STAFF RECOMMENDATION
201 N 11th Street (0 N 11th Street)
February 17, 2021

Application: New Construction—Infill
District: Lockeland Springs-East End Neighborhood Conservation Zoning Overlay
Council District: 06
Base Zoning: MUL-A
Map and Parcel Number: 08309008800
Applicant: Manley Seale, Architect
Project Lead: Sean Alexander, sean.alexander@nashville.gov

Description of Project: The applicant is proposing to construct a new mixed-use building, with a corner commercial component and a row of six attached townhouses. The building will address N 11th Street and Forrest Avenue, and both components of the building will have three-stories.

Figures 2 & 3: Current proposal, corner commercial component, N 11th Street Elevation on left and Forrest Avenue Elevation on right.

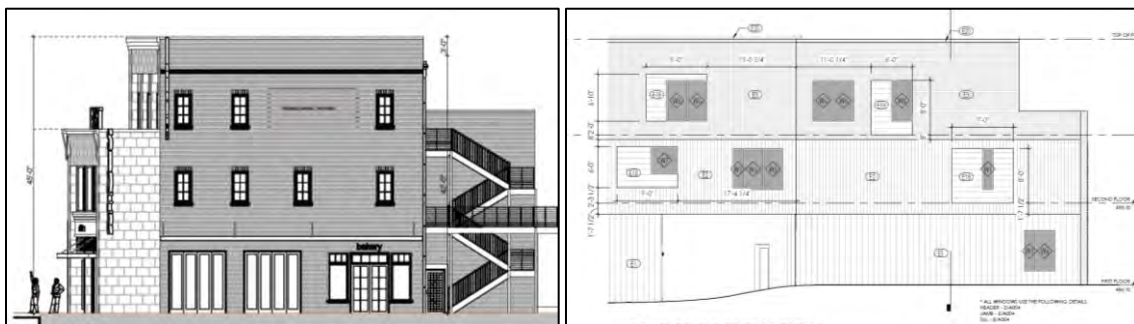
Height & Scale: The structure will have a two-story commercial form at the corner, twenty-six feet (26') tall from grade to the top of the parapet at the front, with a third story stepped back ten feet (10') from both street-facing facades, rising to a maximum height of thirty-five feet (35'). The façade along N 11th Street will be forty-three feet (43') wide, including an eight foot (8') wide vestibule at the left, stepped back five feet (5') from the primary wall. The commercial component will turn the corner with a façade extending eighteen feet (18') along Forrest Avenue.

Staff finds that the third story on the commercial form should step back from the left/north side where the building is adjacent to an historic building, in addition to stepping back from the two street-facing facades. Although the adjacent historic building has a two and one-half story form, it has a much deeper setback typical of historic houses. Additionally, staff finds that a canopy at the third-story roof level, projecting three feet (3') into the stepped back area, increases visibility of the third story and negates the effect of the setback which is intended to reduce the perceived height and scale.

1. The third story on the commercial form should step back from the left/north side where the building is adjacent to an historic building;
2. The canopy on the third-story roof of the commercial component should be removed;
3. The third story on the townhouses should be completely stepped back ten feet (10');
4. The height of the townhouses should taper to two-stories on the east, adjacent to an historic one and one-half-story house;
5. Balconies should not cantilever or project. Rather than having a conspicuous railing material, the visibility of upper-level decks should be concealed behind a masonry parapet rather than a railing; and
6. Material samples, colors, and mechanical and utility locations should be administratively approved.

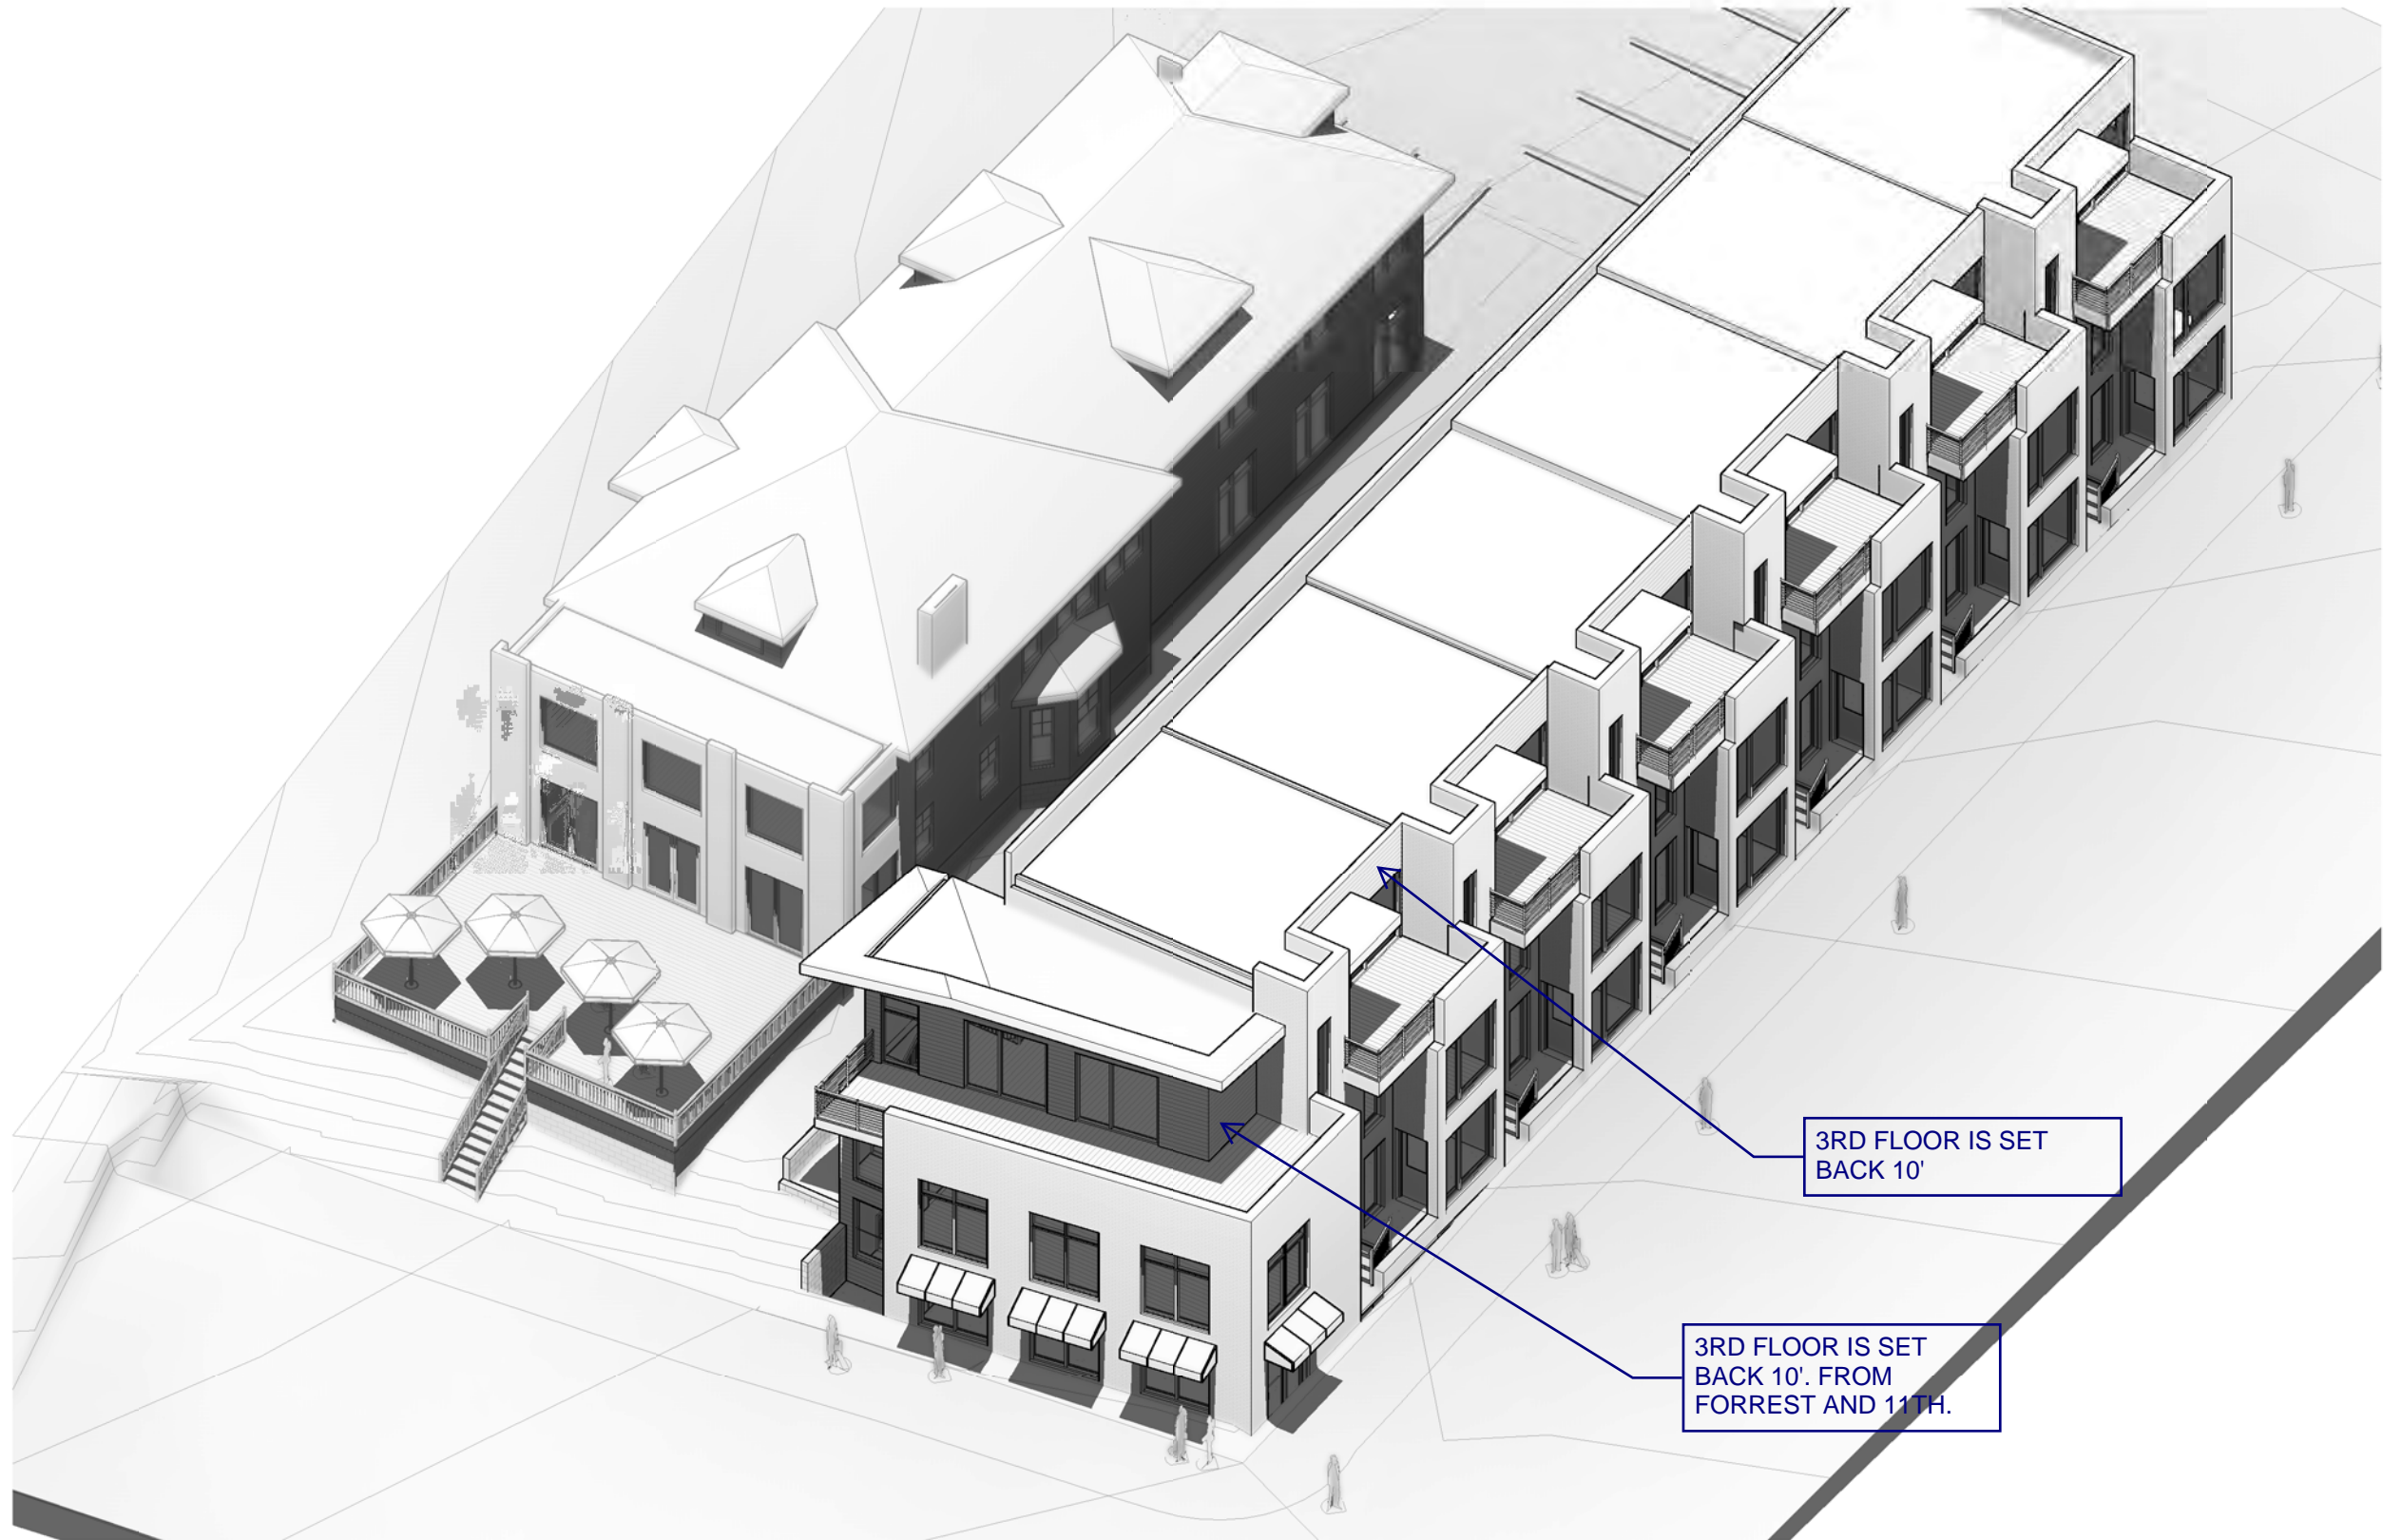
Appurtenances & Utilities: The locations of the HVAC units are not indicated. Appropriate locations for these and other mechanicals would be beyond the midpoint of the building on non-street-facing elevations, or on the roof.

Additional information is needed to determine if the project meets section II.B.9 of the design guidelines.

1 00-ARCHITECTURAL SITE PLAN H
 1" = 20'-0"

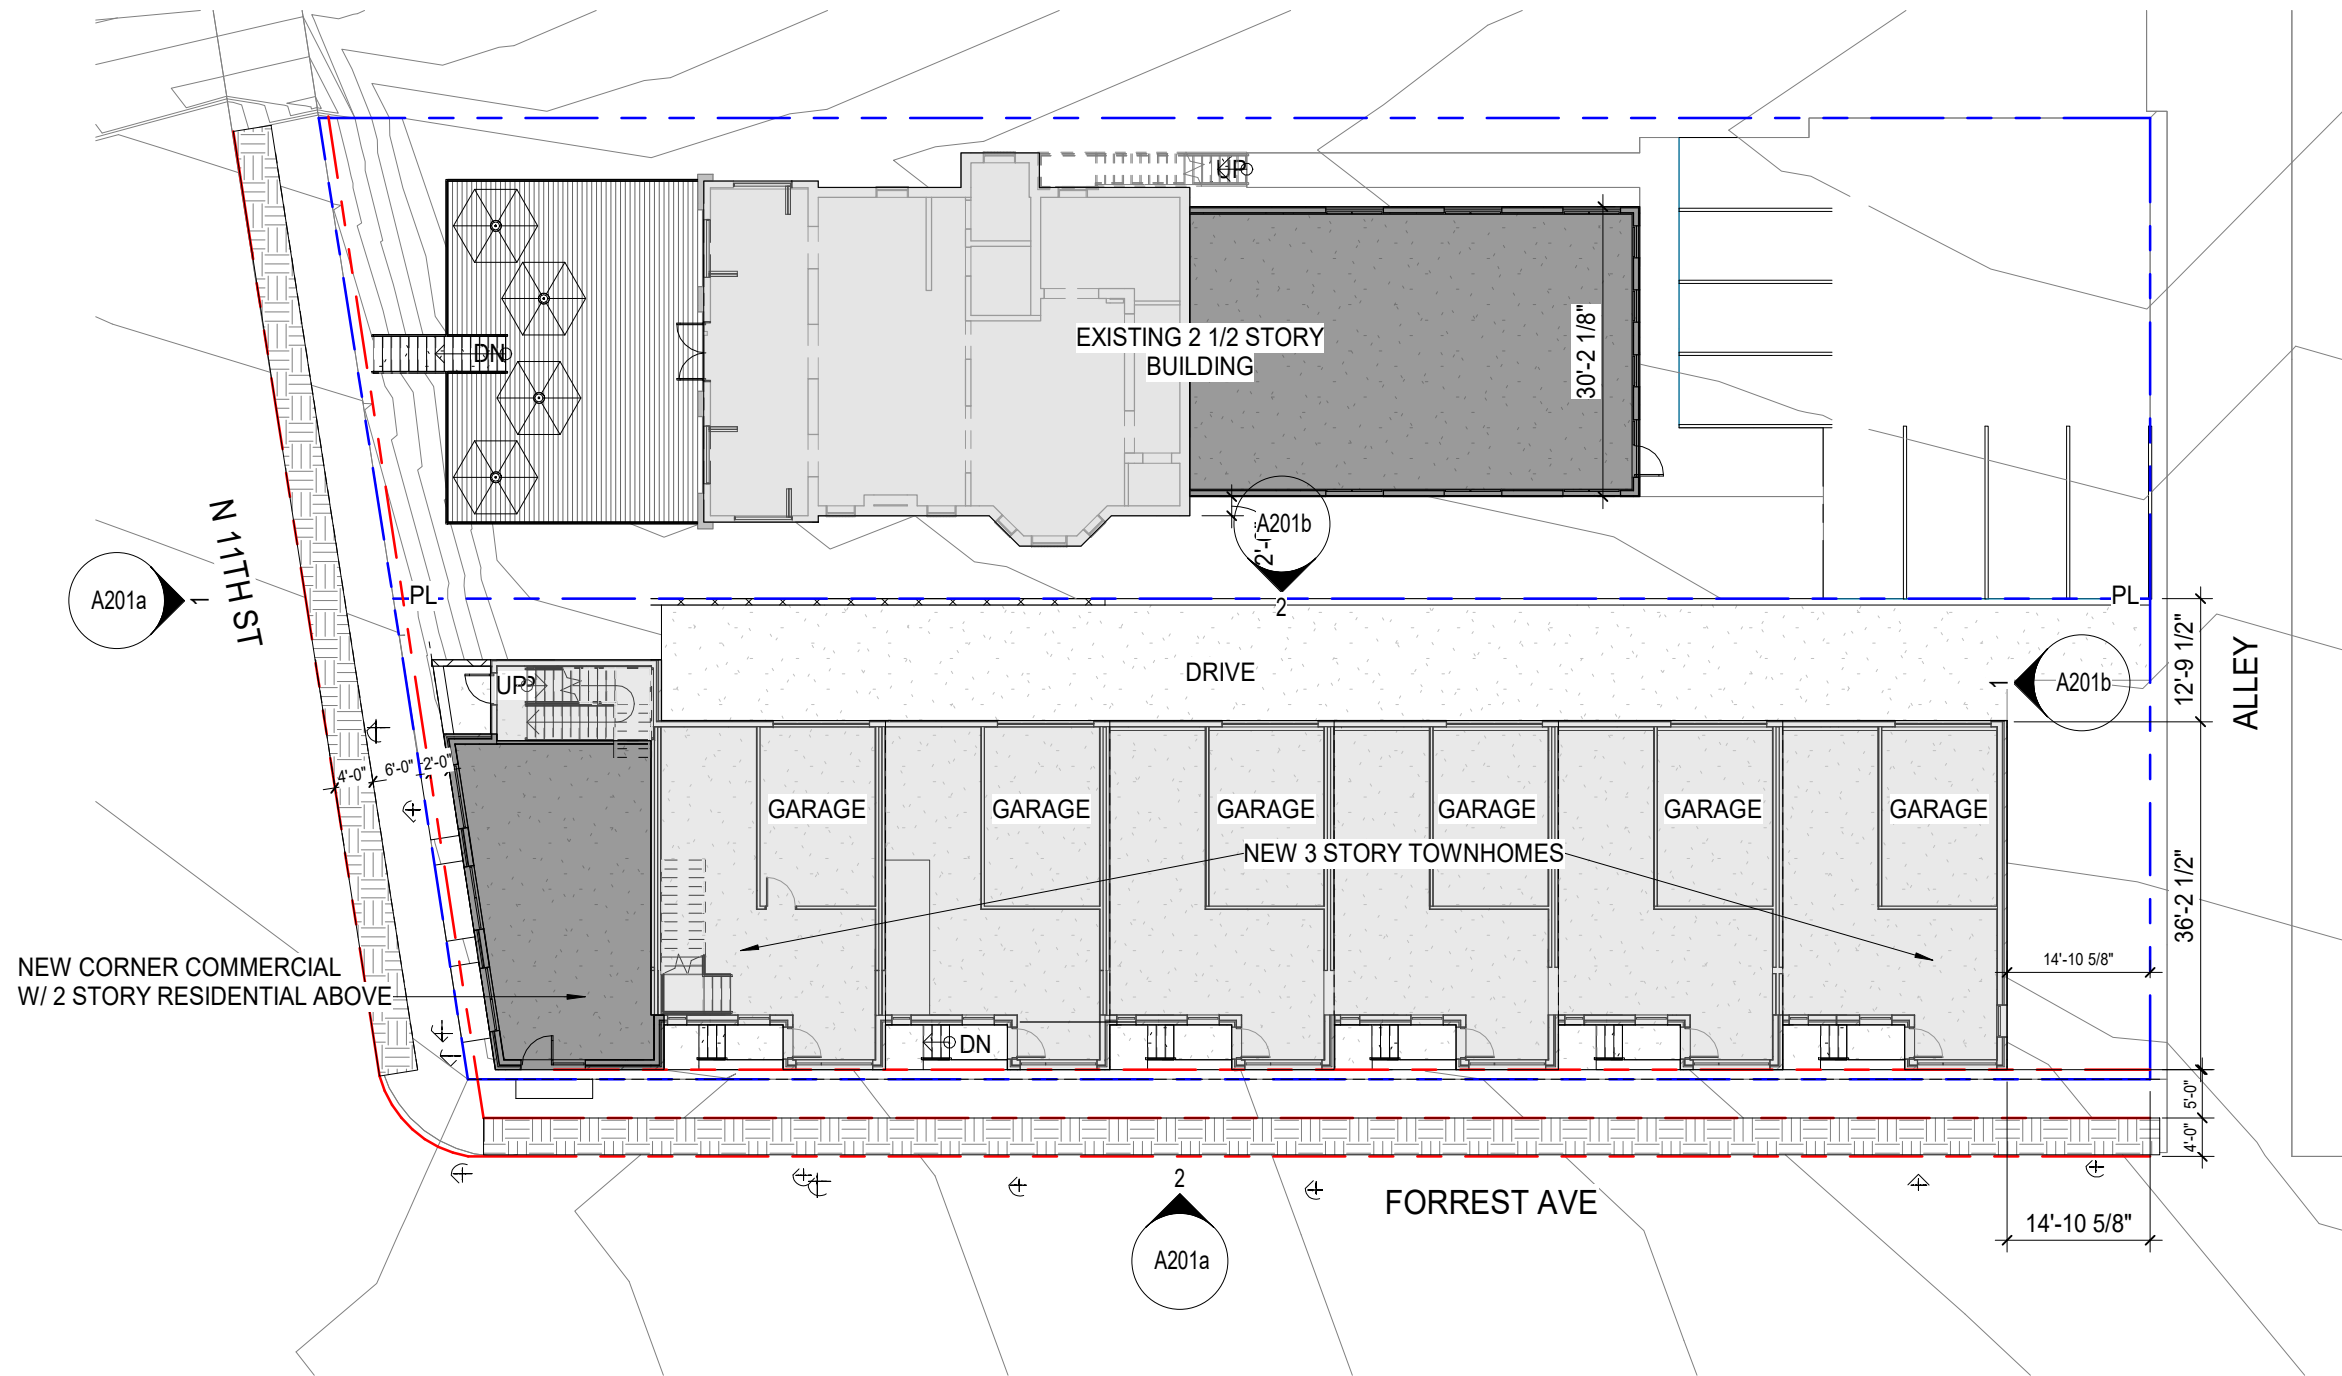
Setback & Rhythm of Spacing: The corner commercial component will be located at the edge of the sidewalk along N 11th Street and Forrest Avenue. The left or north side of the commercial component will be five feet (5') from the property line. This is typical of commercial building types, which often had little or no setback historically. The townhouse component will have zero setback from the sidewalk along Forrest Avenue, a fifteen foot (15') setback from the alley to the east, and a thirteen foot (13') setback from the property line to the north.

The setbacks of the townhouse component are more comparable to commercial building types than the residential building types typical of Forrest Avenue. However, staff finds that because this development is near the edge of the overlay where the context transitions from residential to institutional and commercial, these setbacks are appropriate.

Staff finds that the setbacks for the proposed addition will meet section II.B.3 of the design guidelines.
